FURNISHING CORRECTION TO MINOR ERROR IN TECH SPEC FIGURE 3.1-2 ("CEA
INSERTION LIMITS VS. THERMAL PWR WITH 4 REACTOR COOLANT PUMPS OPERATING"),
AND INFO RE SEQUENCE OF EVENTS LEADING TO ERROR... W/ATT.

PLANT NAME: ST LUCIE #1

Re: St. Lucie Unit 1
 Docket No. 50-335

Power Dependent Insertion Limit Curve

Figure 3.1-2 CEA Insertion Limits vs THERMAL POWER with 4 Reactor Coolant.
Pumps Operating

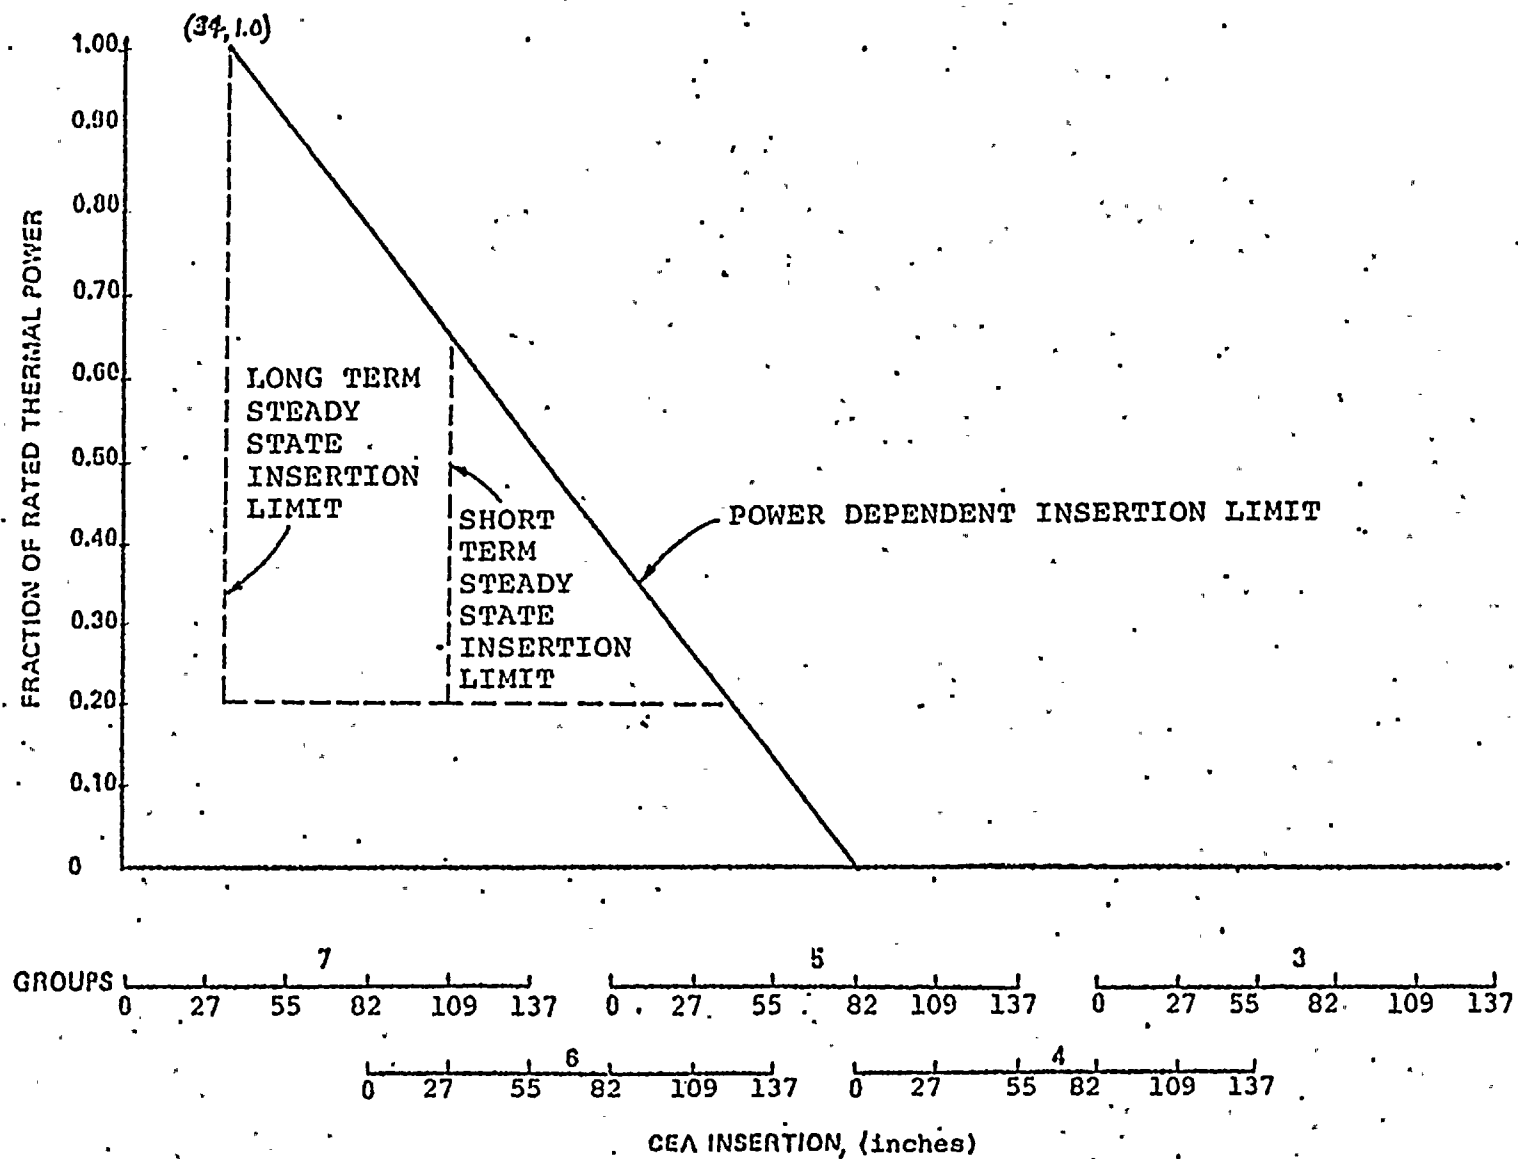
The purpose of this letter is to correct a minor error in Technical Specification Figure 3.1-2 ("CEA Insertion Limits vs. Thermal Power with 4 Reactor Coolant Pumps Operating"). The sequence of events leading to the error were as follows:

In order to make the curve consistent with the existing Technical Specifications and easier to use, the "CEA Insertion" scale was changed from per cent to inches. The coordinates in the upper left corner of the figure should have been changed from (25,1.0) to (34,1.0), but this was overlooked. The actual position of the PDIL curve was correct; that is, the full power insertion limit corresponded to 34 inches (25% of 137 inches) on the "CEA Insertion" scale, but the abscissa was not changed as it should have been.

The RSE was submitted on March 22, 1978, and the NRC approved numerous Cycle 2 Technical Specification changes by issuing Amendment 27 to Operating License DPR-67 on May 26, 1978. Figure 3.1-2 was issued with the (25,1.0) coordinates intact, but the PDIL curve had been positioned such that, at full power, it corresponded to 25 inches on the "CEA Insertion" scale. The correct curve, as supported by the RSE, should have been positioned such that the full power limit corresponded to 34 inches and the coordinates in the upper left corner read (34,1.0). A corrected Figure 3.1-2 is attached.

Figure 3.1-2 as issued by Amendment 27 is conservative in that it limits Group 7 insertion at full power to 25 inches rather than 34 inches. Since Group 7 is used to dampen Xenon oscillations, the conservative PDIL limit decreases operating flexibility. Limiting Group 7 insertion to 25 inches could permit a situation where power would be limited during a Xenon oscillation because compensating rod insertion past 25 inches would be prohibited. In order to correct our error, and to gain operating flexibility, we request that Figure 3.1-2 be reissued to conform with the attached corrected figure. Your assistance will be appreciated.
